PCN #: 2424 Rev 2 (Interim Update)

PCN Title: OSE BGA Assembly and Test site transfer and addition of ASE Chungli Assembly and Test site for BGA packages plus Marking Change

New Marking

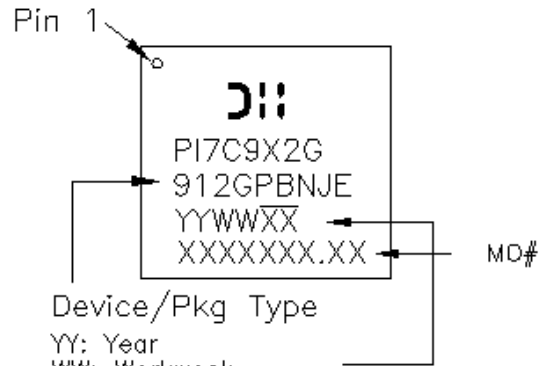
As part of the changes above, we will also have a new top marking. New parts from OSE and ASE Chungli will have a different logo and an added MO # (Manufacturing Order) for added traceability. Part number and date code marking will remain the same.

YY: Year
 WW: Workweek
 1st X: Assembly Code
 2nd X: Fab Code
 Bar above fab code means Cu wire
 Bar above assy code means ULA BOM
